OPTIONAL SERVICE BULLETIN

NO. OSB 40-066

NO. OSB D4-072

Large Rudder.
ATA-Code: 55-40

Sketch 1: Cut out for rudder mass balance

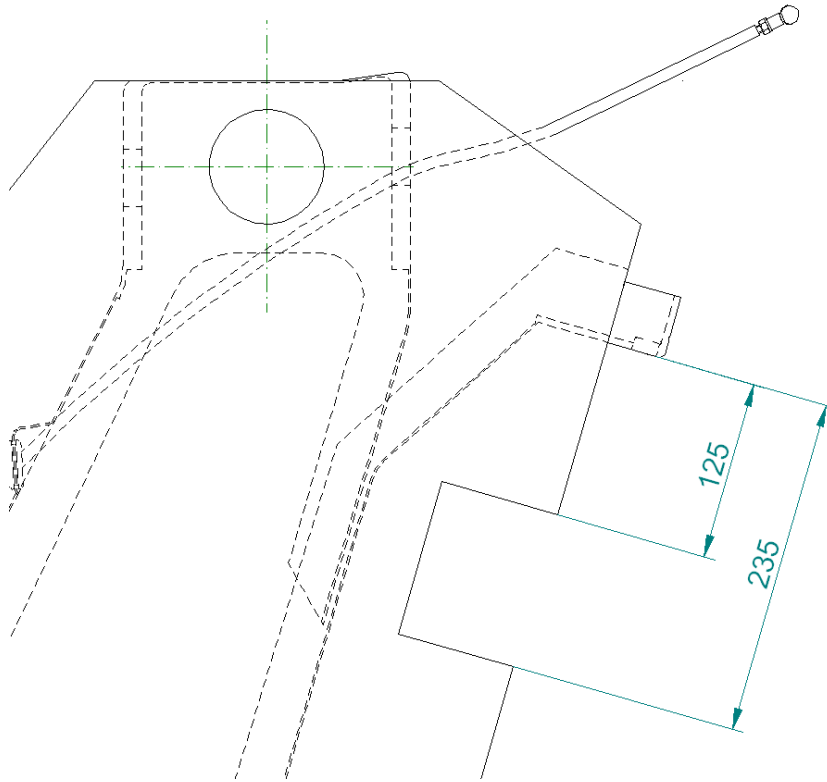
2.	Remove old rudder i.a.w. AMM Doc. No. 6.02.01 Section 55-40.
3.	Resize the rudder mass balance cut out on the vertical stabilizer (refer to Sketch 1).

4.	Install new rudder i.a.w. AMM Doc. No. 6.02.01 Section 55-40.
5.	<p>Check for proper gap (3 mm / 0.12 in minimum) between rudder and stabilizer frame at full rudder deflection LH and RH and during travel.</p> <p>Check for clearance between elevator push rod and rudder mass balance in nose up and nose down position (minimum 2 mm / 0.08 in).</p>
